ORIGINATION FORM

Proposed Revisions to a Standard Plans Index

Index Number: 700-012

Index Title: Single Post Bridge Mounted Sign Support

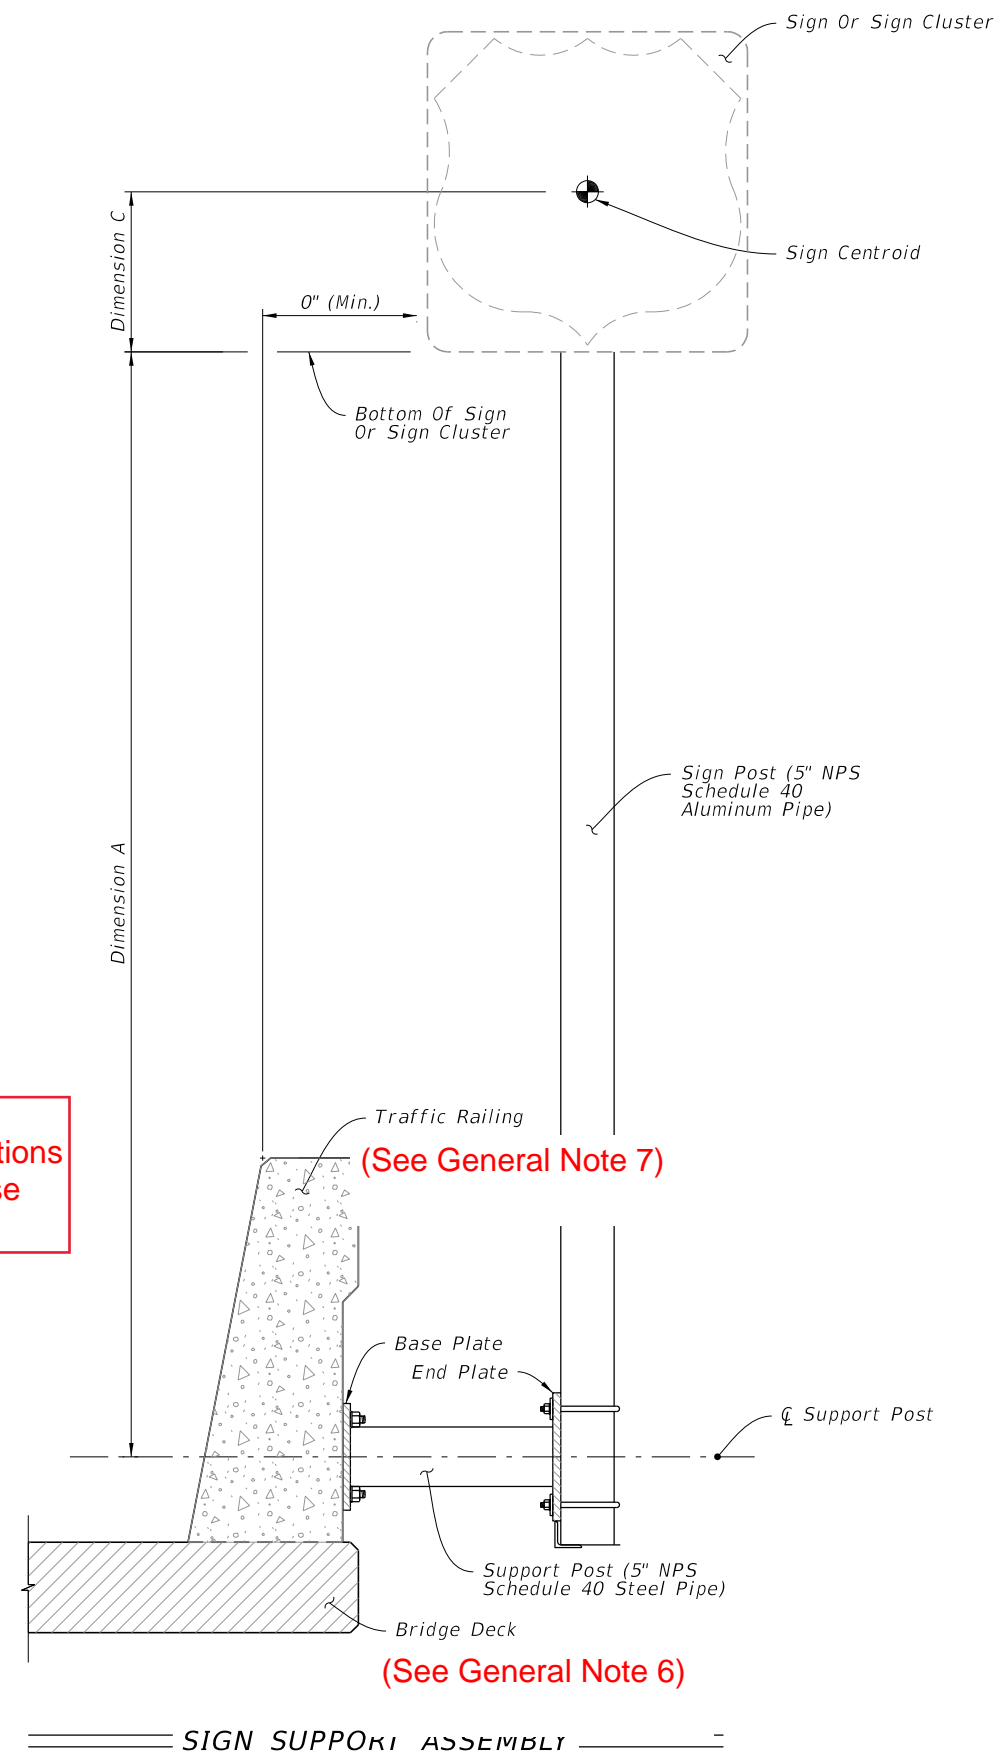
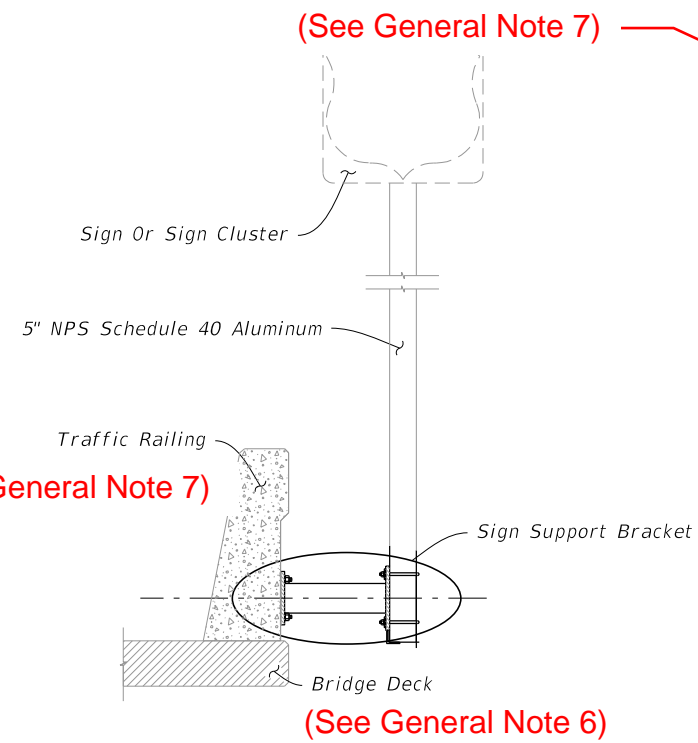
Sheet 1: Updated Notes to General Notes; Added New Note 1 - "Meet the requirements of Specification 700".; Deleted Note 3; Moved Note 4 to Specification 962; Deleted Note 5; Renumbered Notes; Added New Notes from Sheet 2, Note 6 - "Bridge deck shown, approach slabs, junction slabs, and miscellaneous structures are similar." and Note 7 - "Traffic railings are shown. Concrete barriers and parapets are similar."; Updated the General Note references in the SIGN SUPPORT ASSEMBLY detail.

UPDATED: GENERAL NOTES:

ADDED NEW NOTE 1: Meet the requirements of Specification 700.

DELETED

GENERAL COMMENT: Material and fabrication information was deleted. Information is either already covered in Standard Specifications OR will be added to Section 700, 962 or 965 in conjunction with these revisions.

DELETED

- 6. ADDED NEW NOTE 6 AND 7 FROM SHEET 2:**
- 6. Bridge deck shown. Approach slabs, junction slabs, and miscellaneous structures are similar.**

7. Traffic railings are shown. Concrete barriers and parapets are similar.

CHANGED TITLE: Single Post Sign Support Barrier Side-Mounted

CHANGED TITLE:
Single Post Sign Support Barrier Side-Mounted

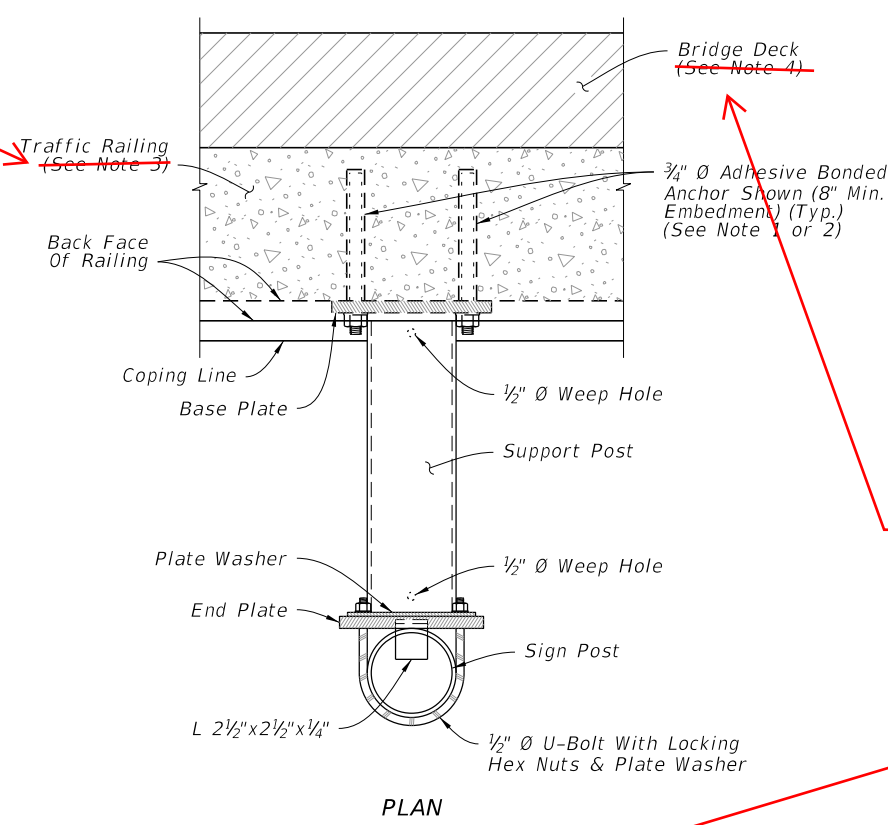
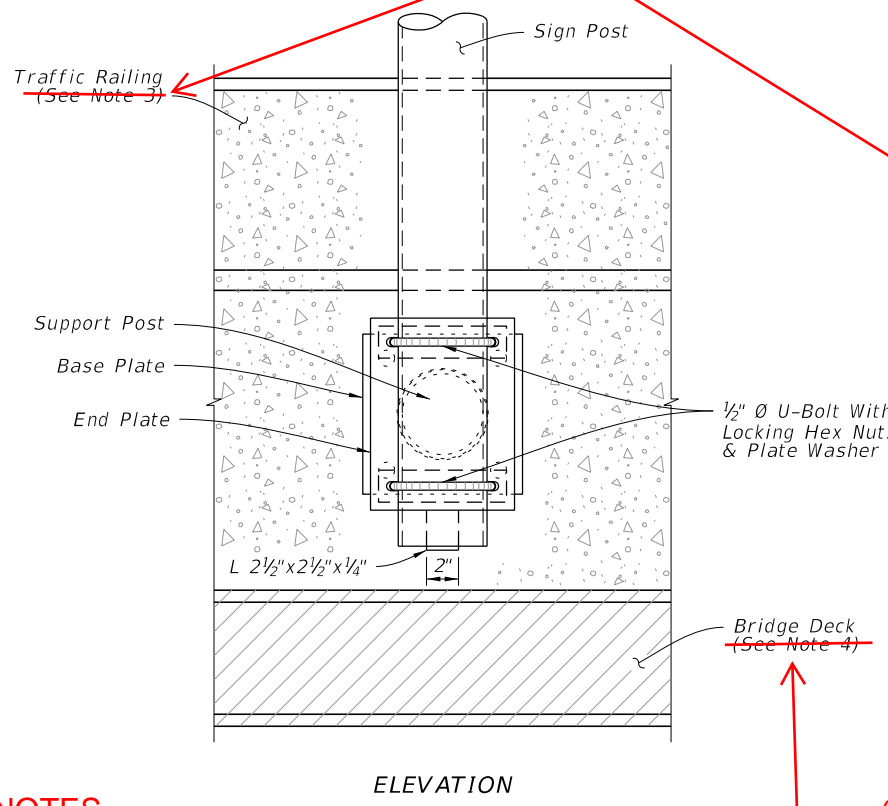
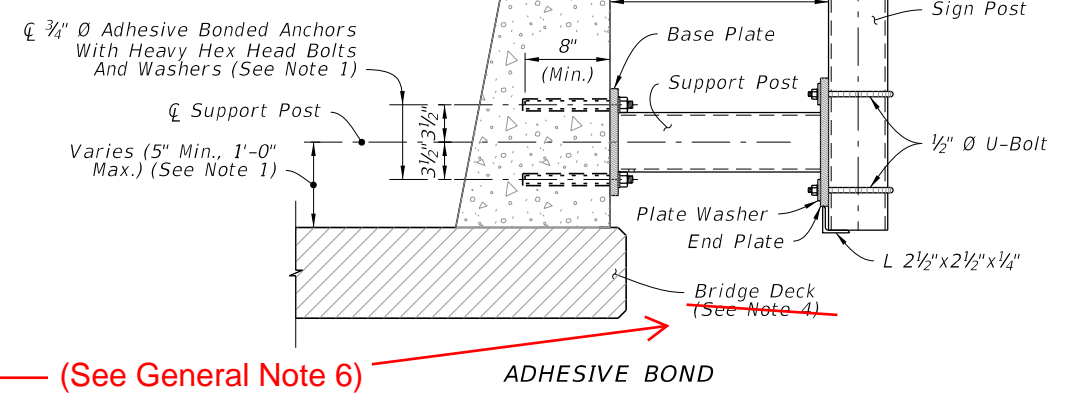
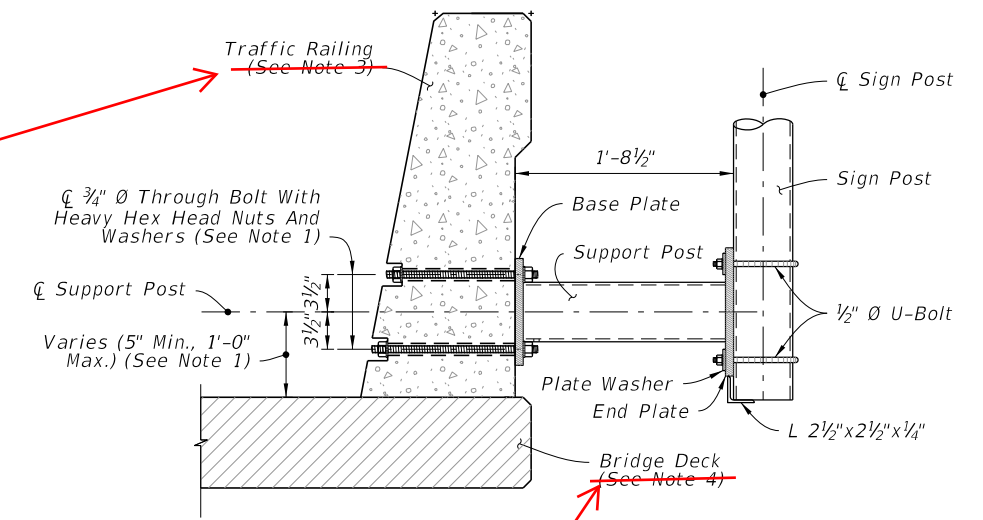
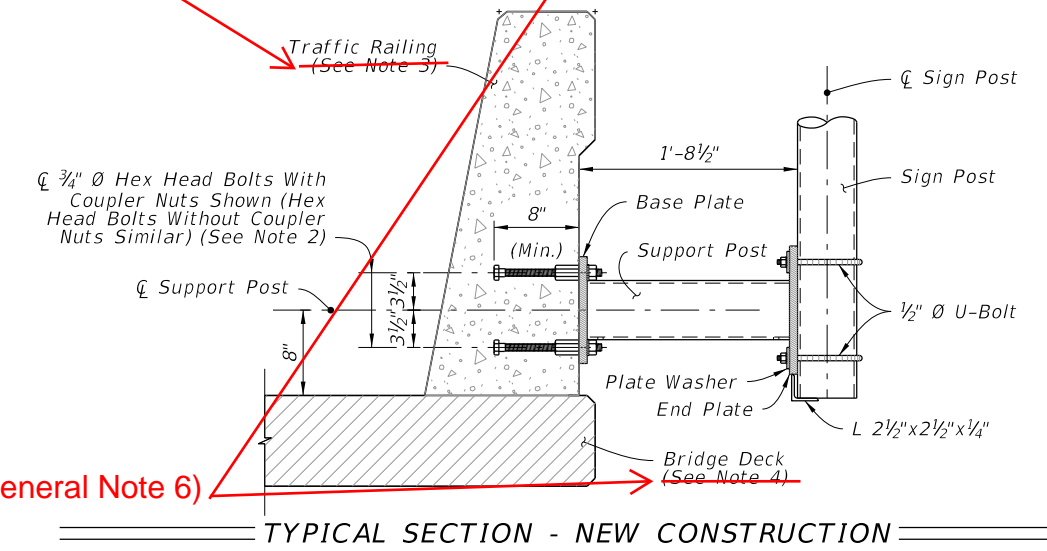
Sheet 2: Moved Notes 3 and 4 to the General Notes on Sheet 1; Updated General Note references.

~~SINGLE POST BRIDGE MOUNTED SIGN SUPPORT~~

- New Traffic Railings:
 - Optional Couplers are shown for slipforming; keep Anchor Bolt coupler threads free of concrete.
 - ~~36" Single-Slope Traffic Railing shown, other Traffic Railings and Parapets are similar.~~

- ~~Bridge Deck shown, Approach Slab and Retaining Wall are similar.~~

MOVED TO GENERAL NOTES

INDEX
700-012

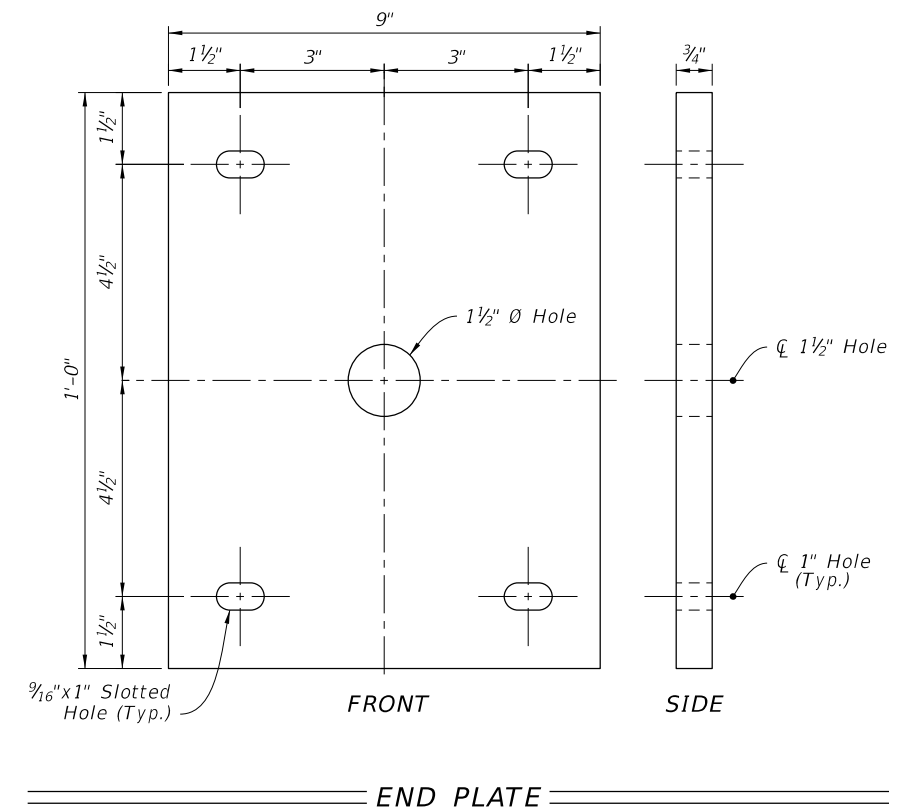
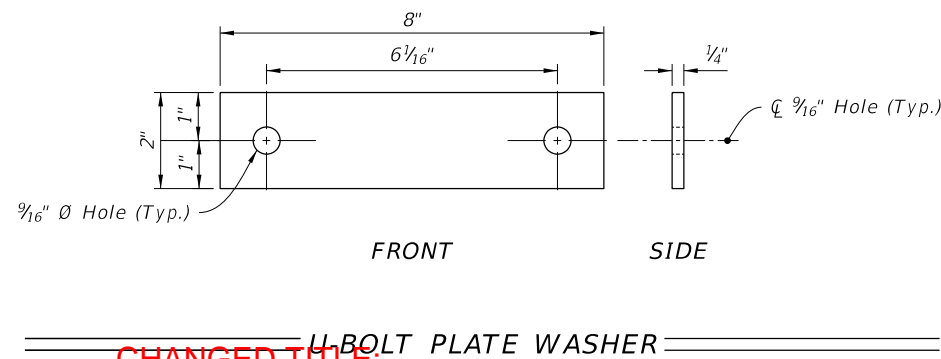
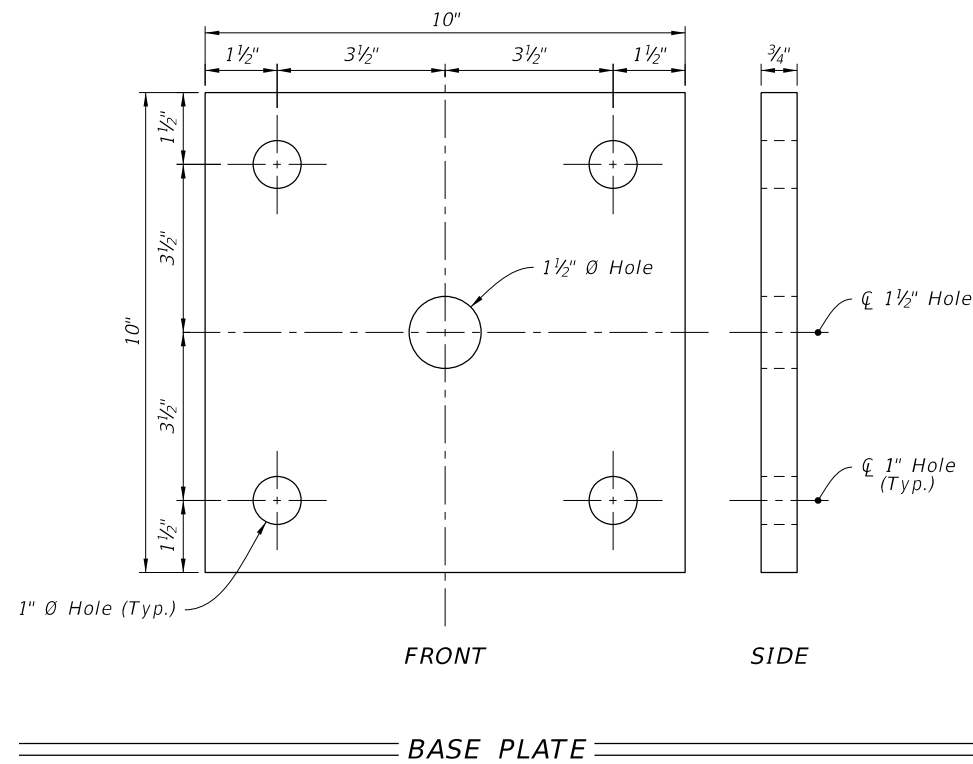
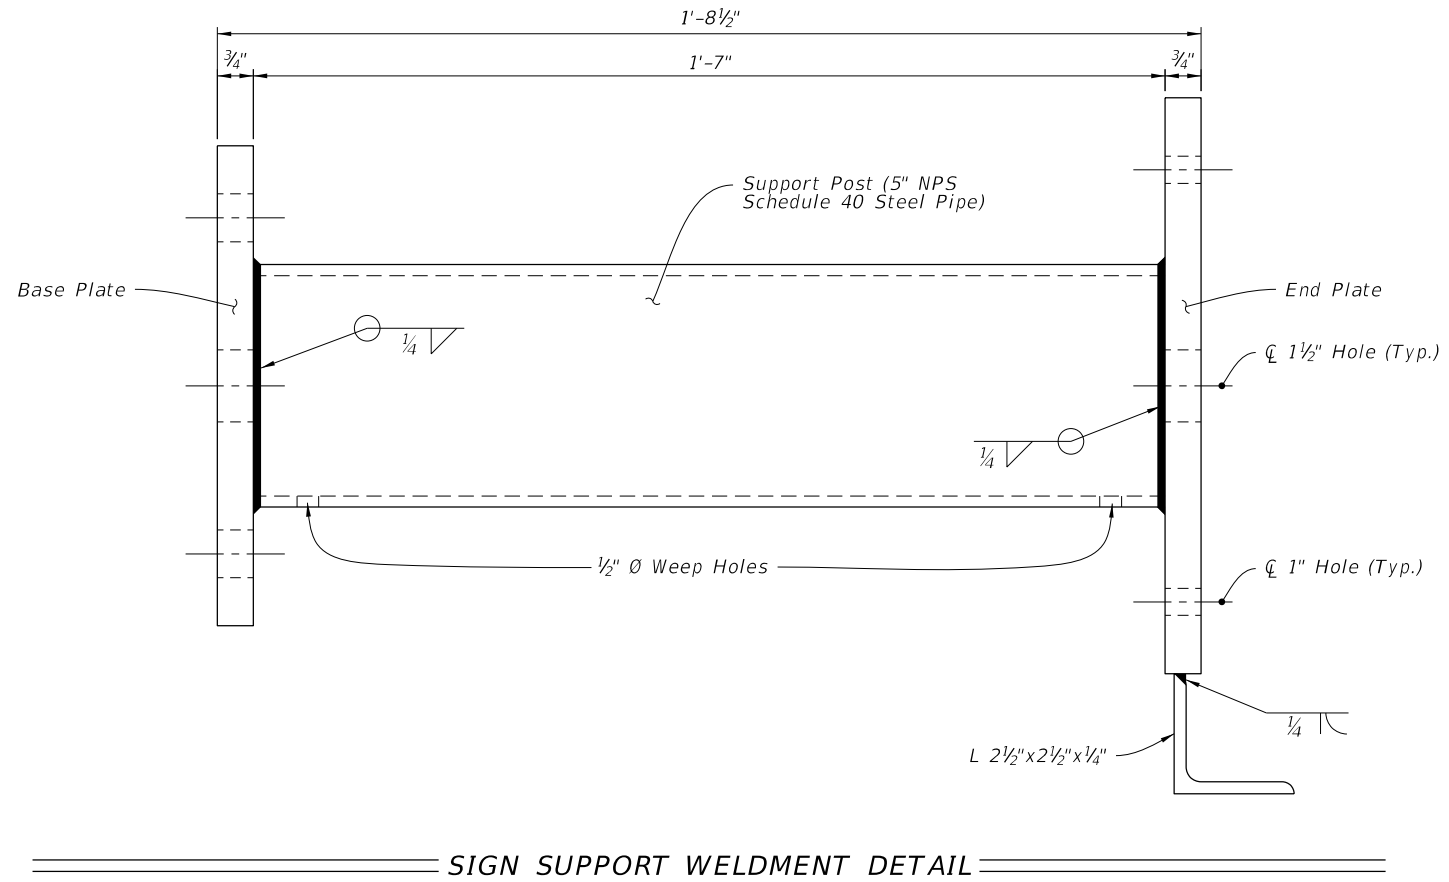
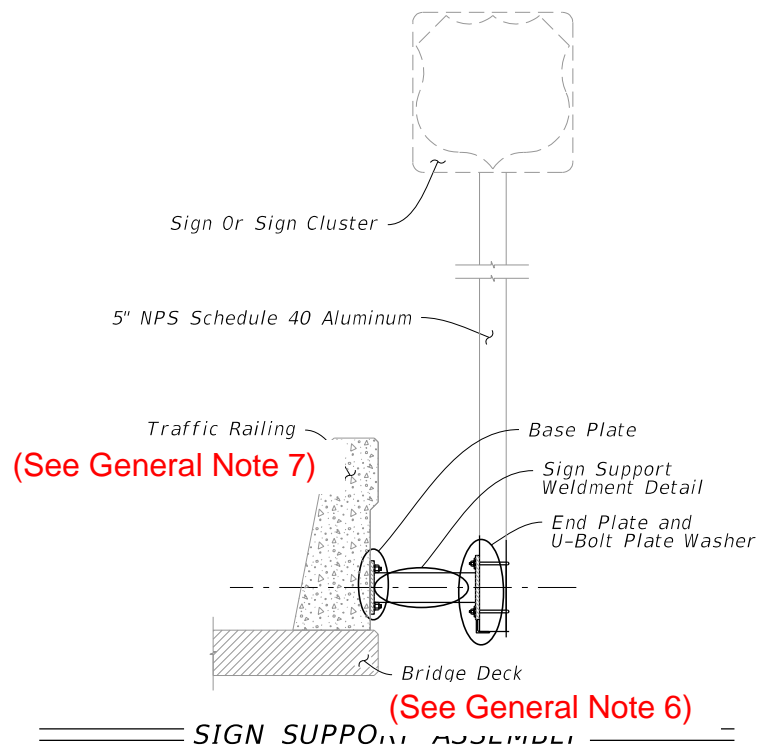
Sheet 3: Updated the General Note references in the SIGN SUPPORT ASSEMBLY detail.

CHANGED TITLE:
Single Post Sign Support Barrier Side-Mounted

~~SINGLE POST BRIDGE MOUNTED SIGN SUPPORT~~
